Subj: Finalization of Second Five Year Review  
Pioneer Sand Company  
EPA I.D. Number: FLD 056 116 965

**FINAL  
SECOND FIVE-YEAR REVIEW REPORT  
FOR  
PIONEER SAND COMPANY  
PENSACOLA,  
ESCAMBIA COUNTY, FLORIDA  
EPA ID: FLD 056 116 965**

**EPA RESPONSE TO COMMENTS**

Figure 1 - Hydrograph

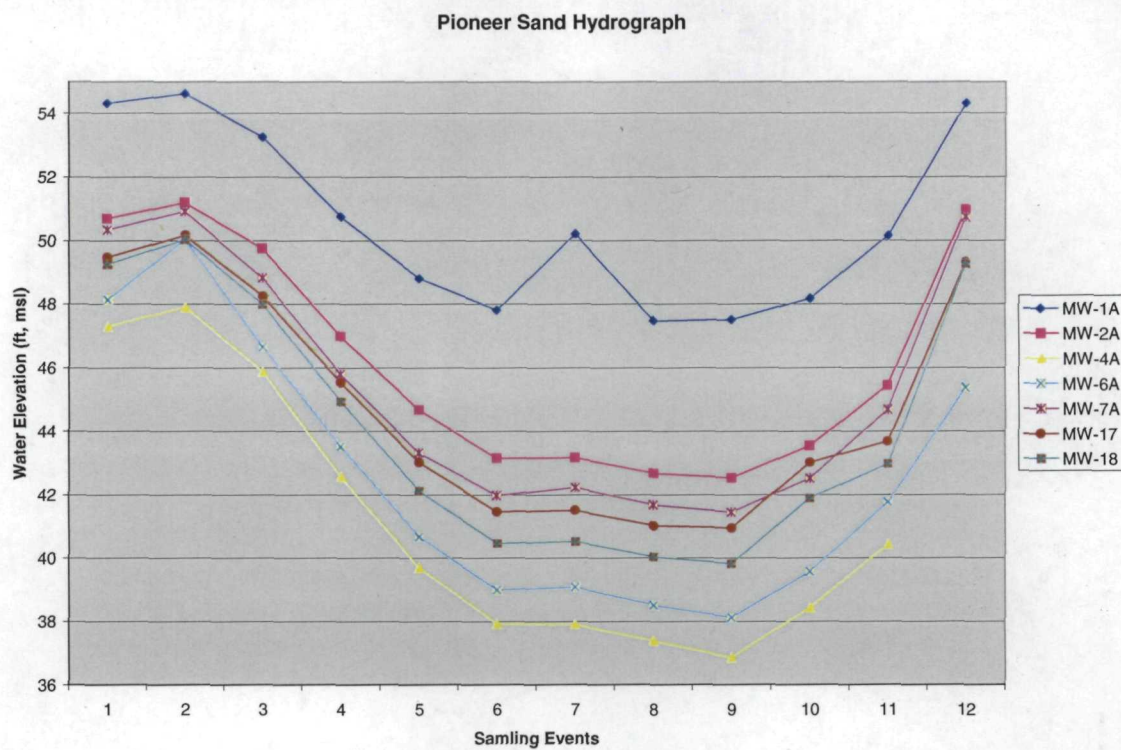
<sup>1</sup> CSES recommended that MW-2A be removed from the monitoring plan. In response, EPA generated a hydrograph from the groundwater elevations collected from all of the monitoring wells. Twelve groundwater monitoring elevations were reviewed (see Figure 1). No flow reversals were measured at MW-2A; therefore, EPA is amenable to removal of MW-2A from the monitoring plan.

6. The recommendation was revised to address the comment (see page 27).
7. The recommendation was added to remove MW-2A from the monitoring system (see page 26).
